Watts Bar Nuclear Plant, Unit 2  
NRC Docket No. 50-391

**Subject: WATTS BAR NUCLEAR PLANT (WBN) UNIT 2 – INSTRUMENTATION AND  
CONTROLS STAFF INFORMATION REQUESTS**

**Enclosure 1**  
**TVA Letter Dated November 24, 2010**  
**Responses to Licensee Open Items to be Resolved for SER Approval**

**Foxboro 08F802403-SC-2001 Drawings**  
**With Proprietary Information Blocks Removed**

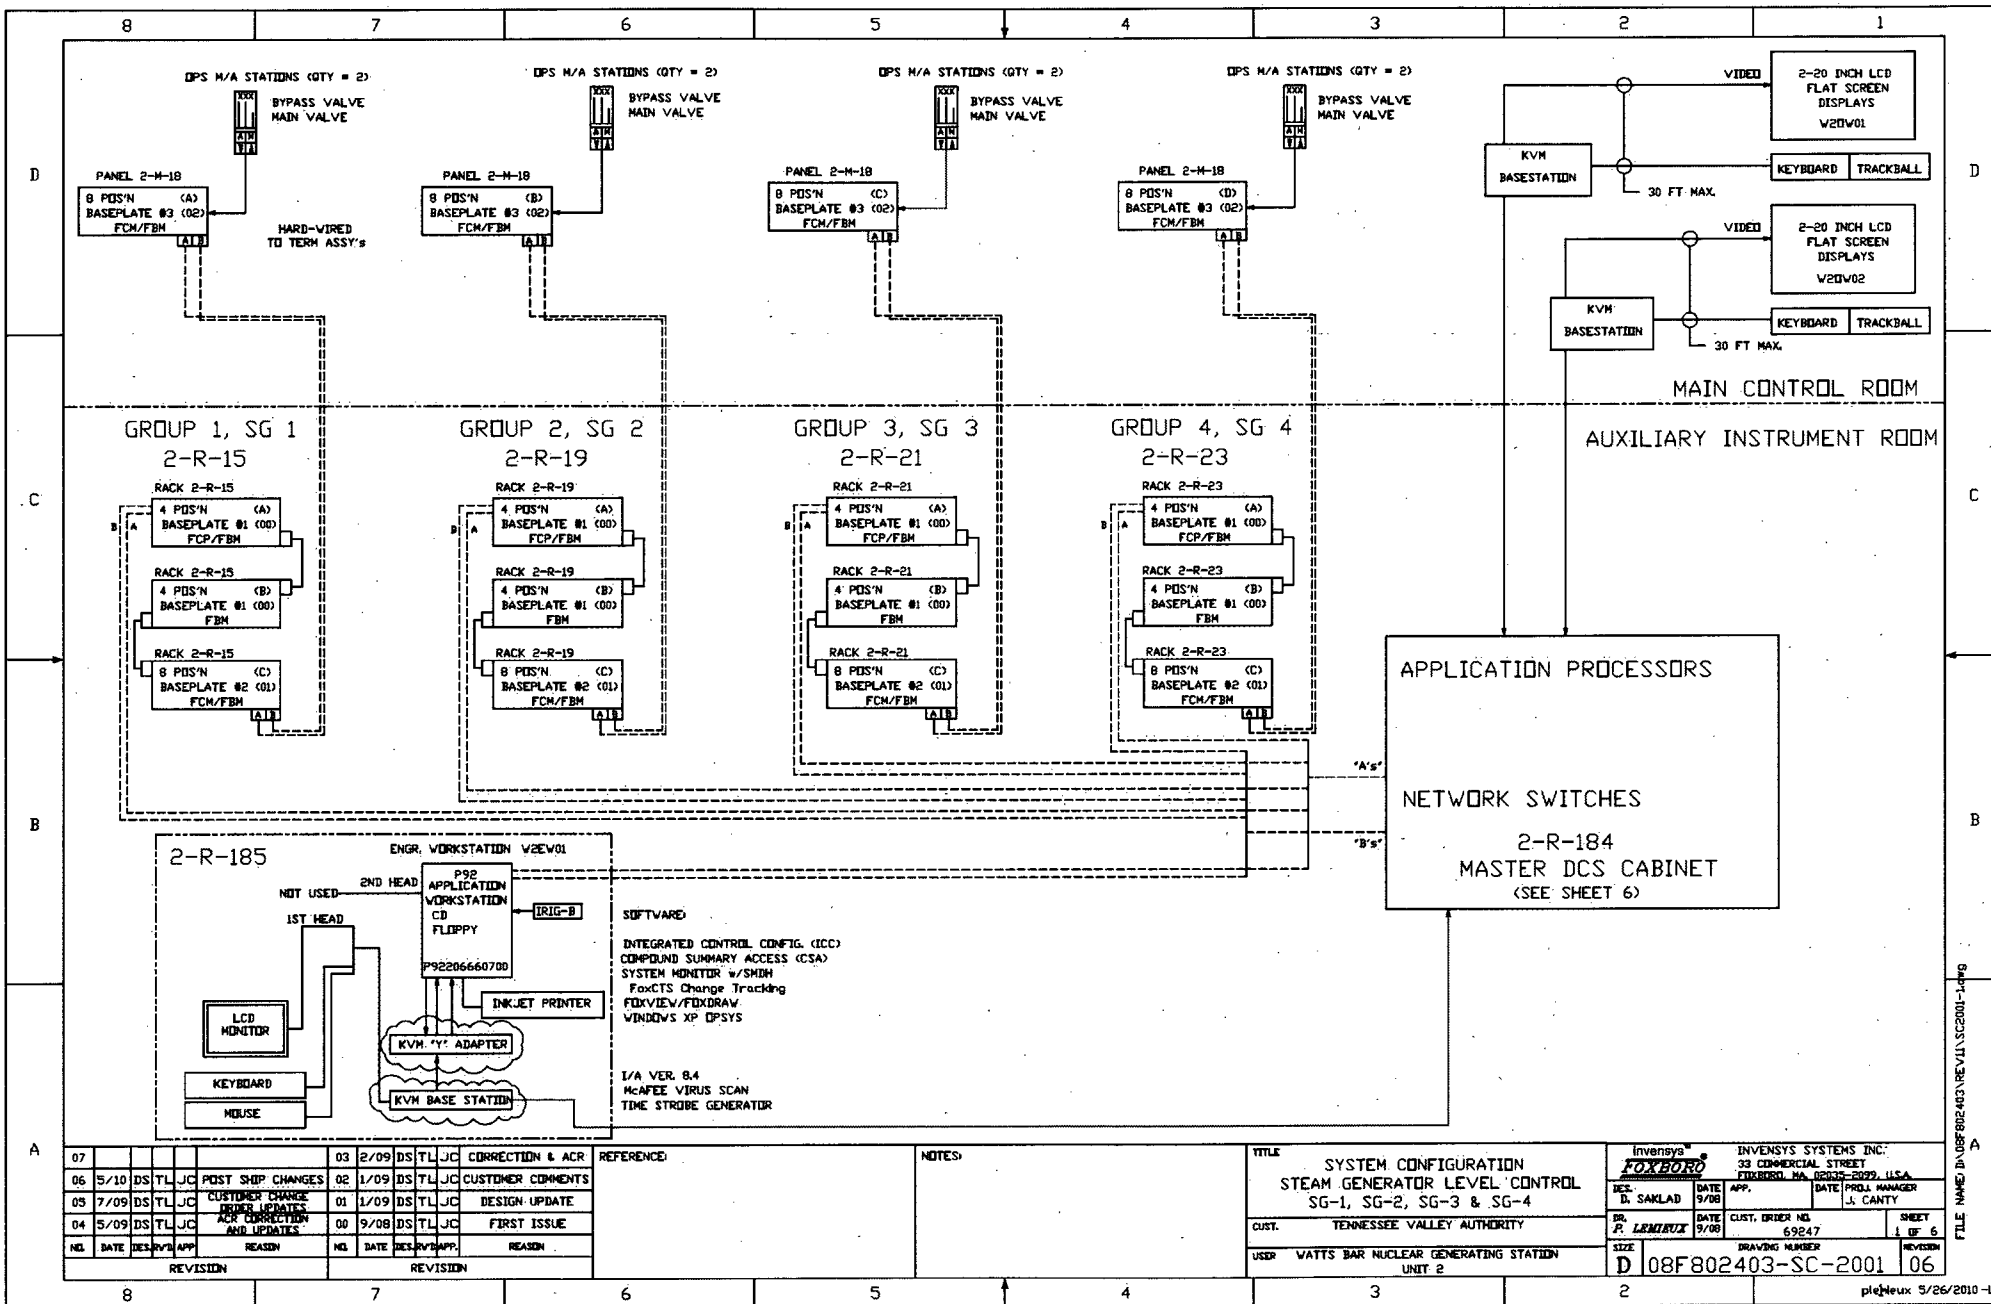
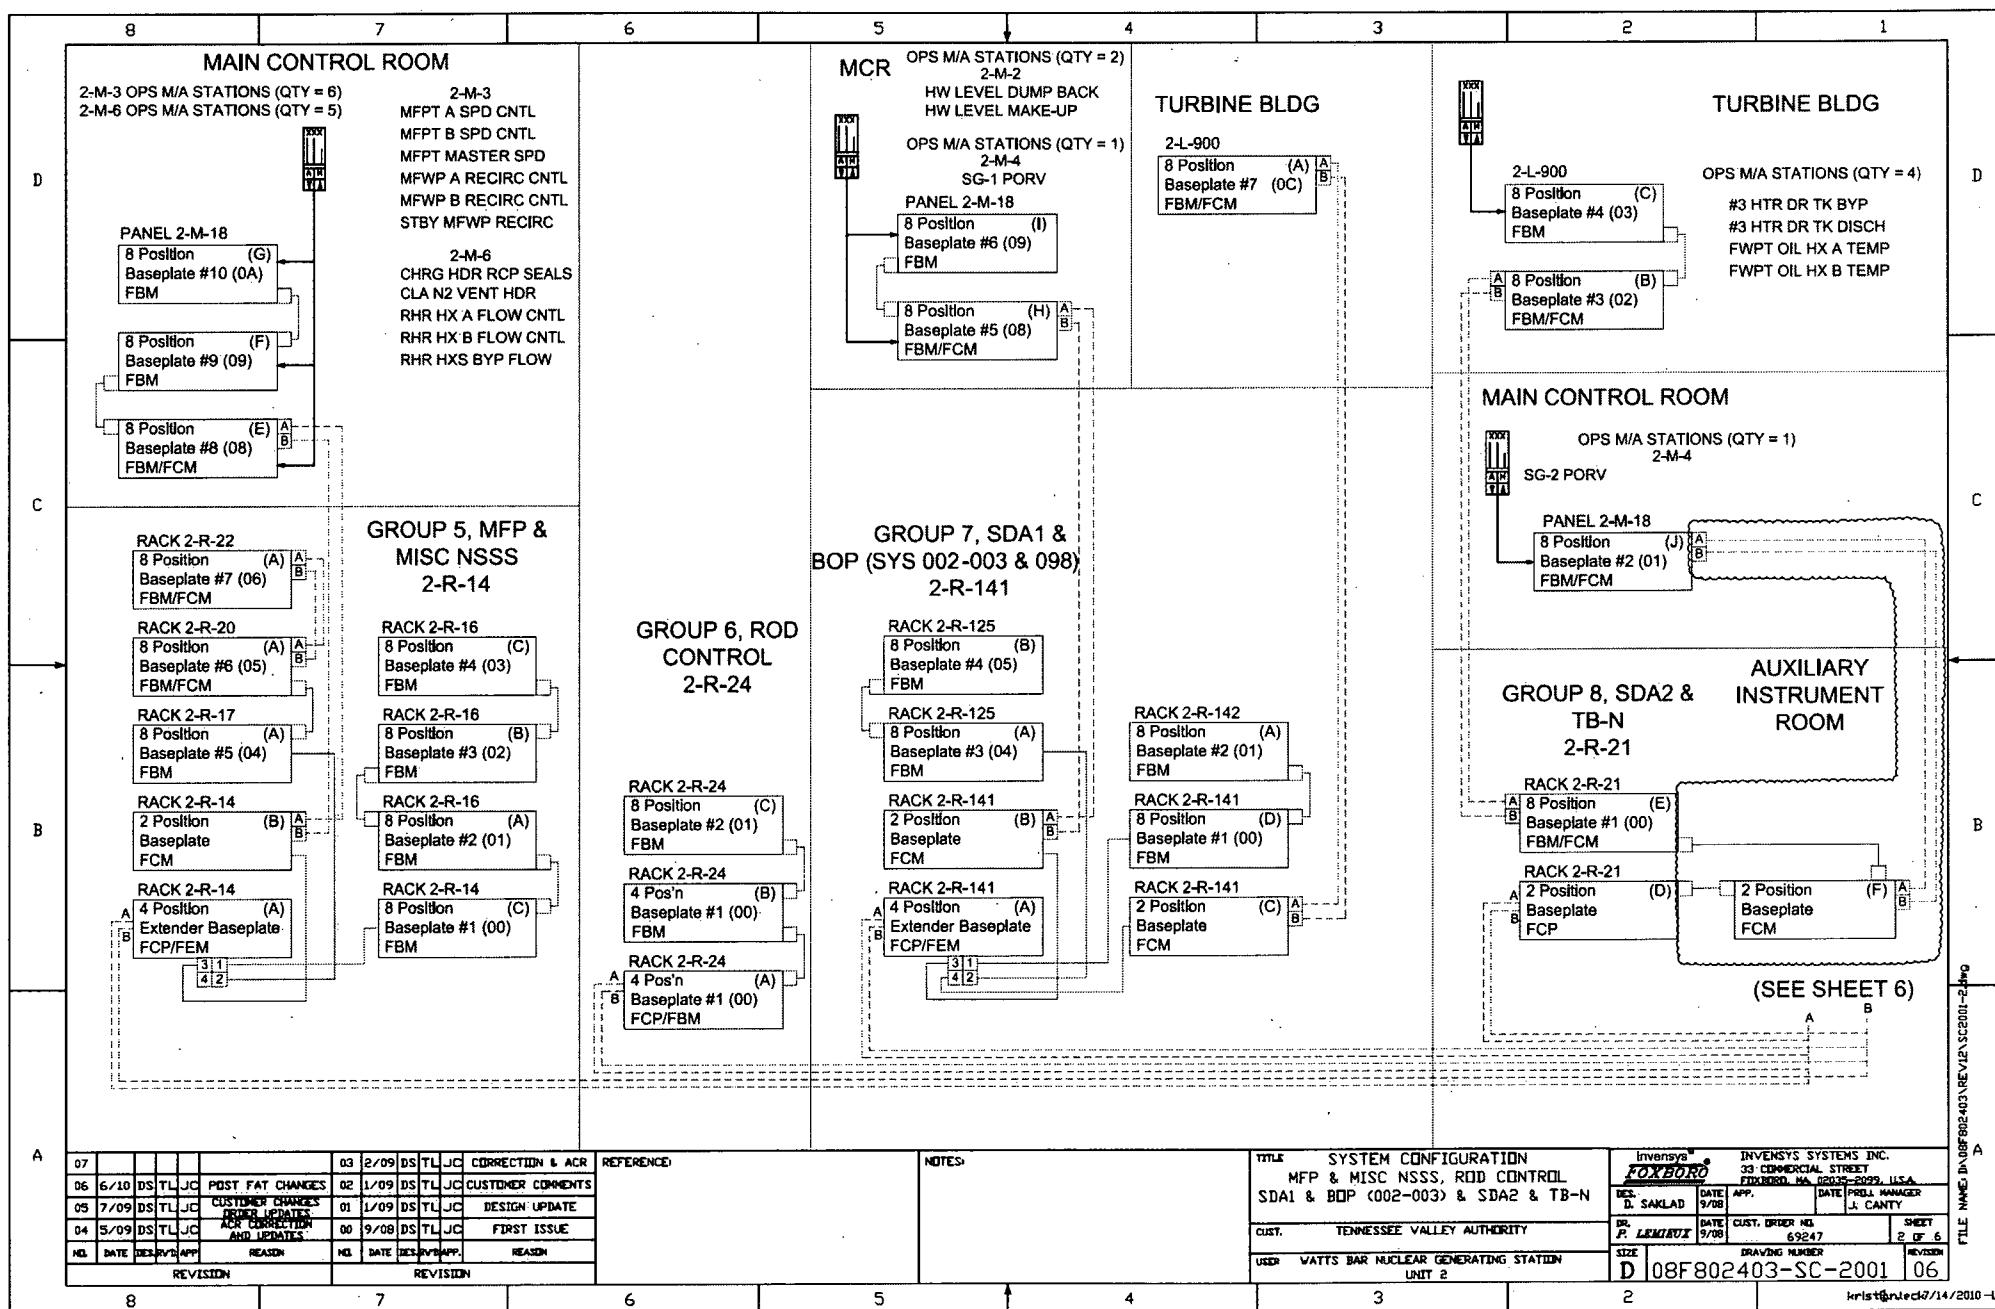
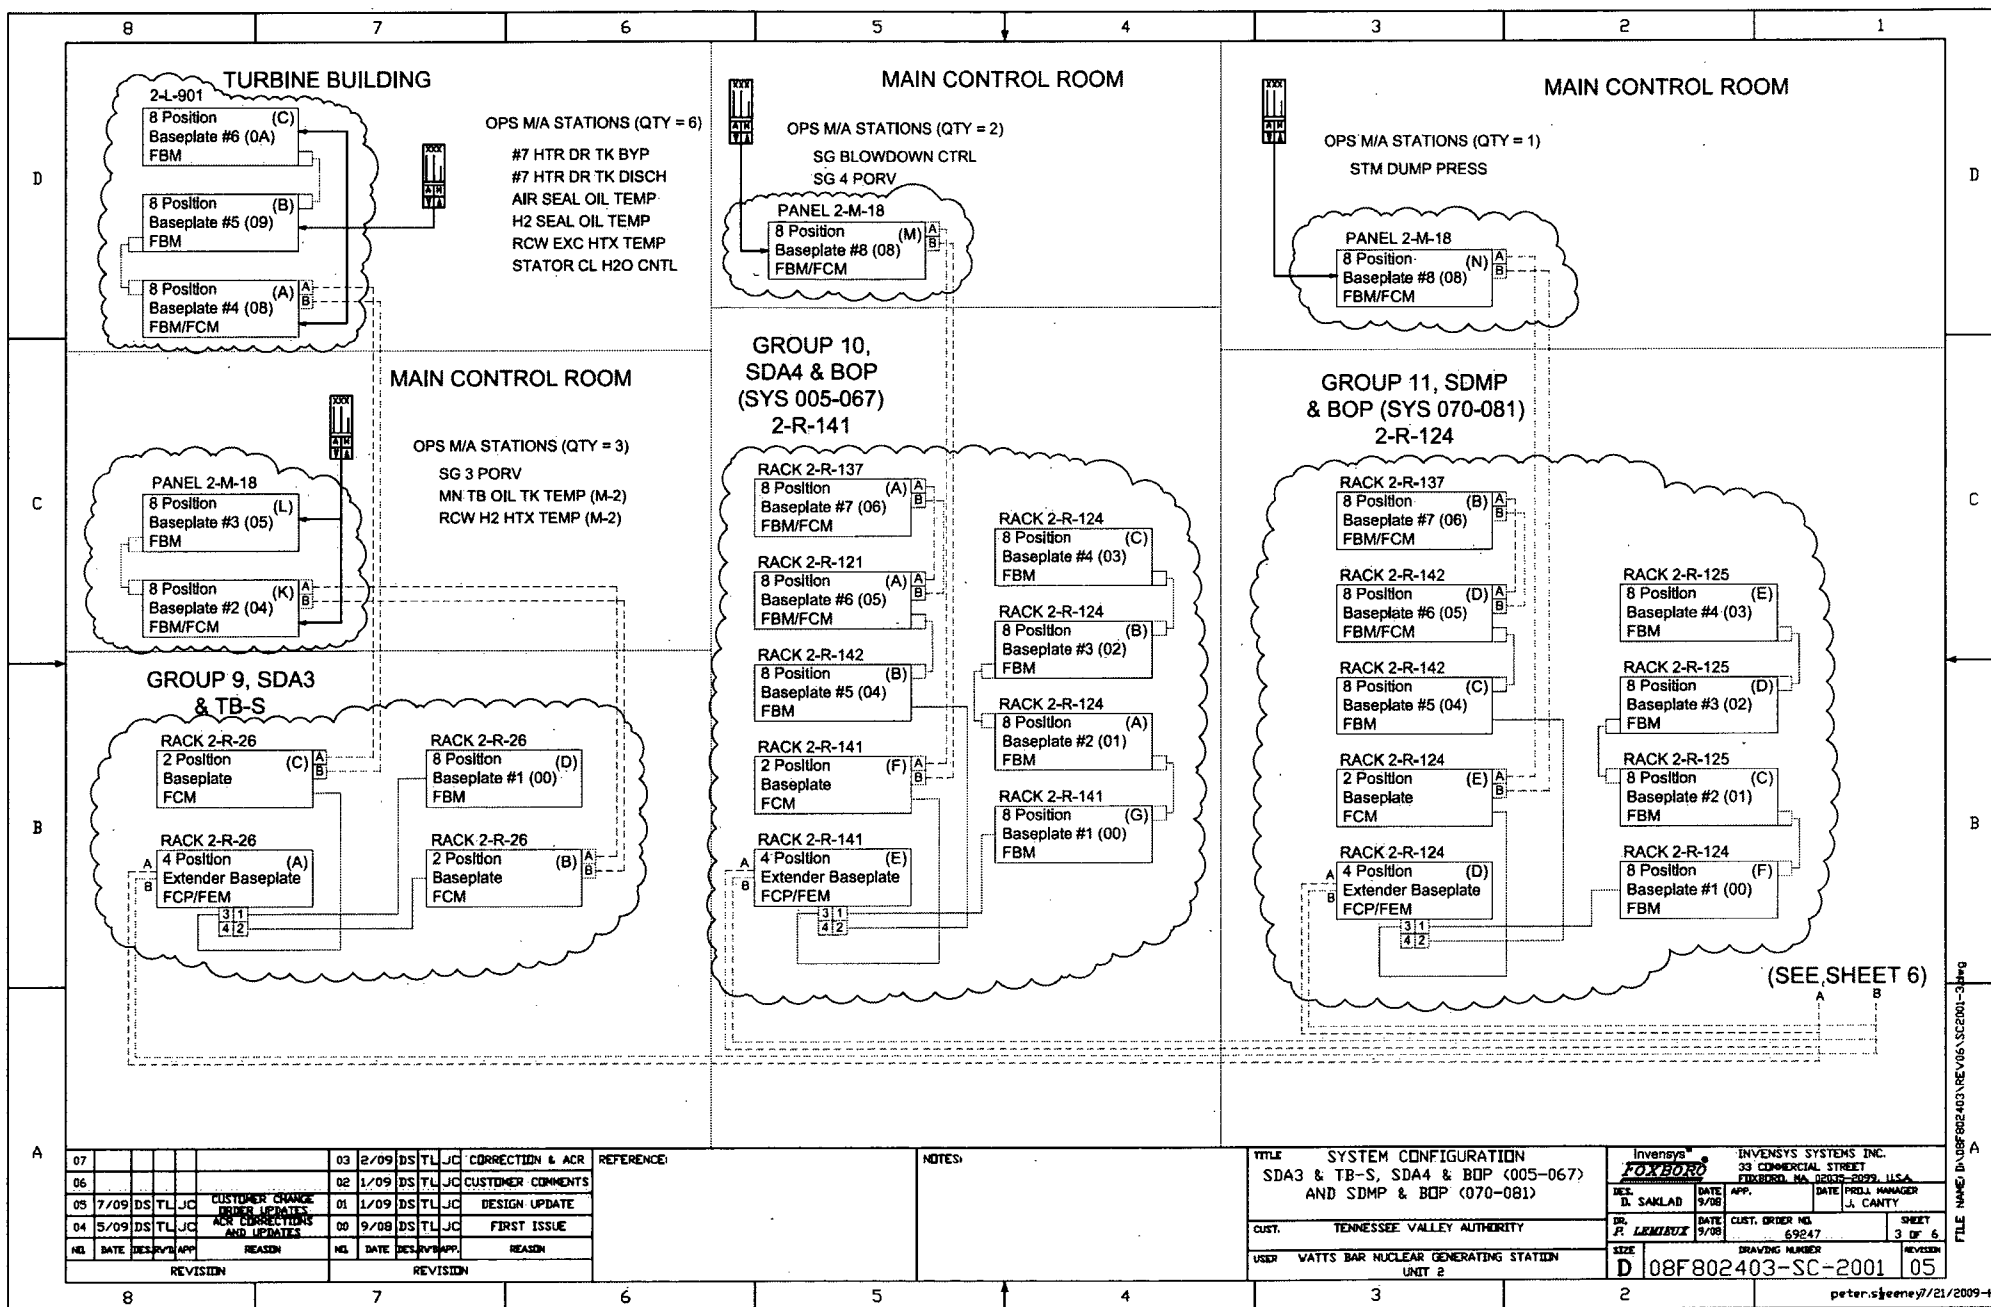
*Attachment 36 [of TVA to NRC Letter dated October 5, 2010 (Reference 2)] contains Foxboro proprietary drawings 08F802403-SC-2001 sheets 1 through 6. An affidavit for withholding and non-proprietary versions of the drawings will be submitted by January 31, 2011.*

In accordance with correspondence from Foxboro, there is no proprietary information contained in the 08F802403-SC-2001 drawings. Based on this, no affidavit for withholding is required. Attachment 1 contains versions of the drawings with the proprietary information block removed.
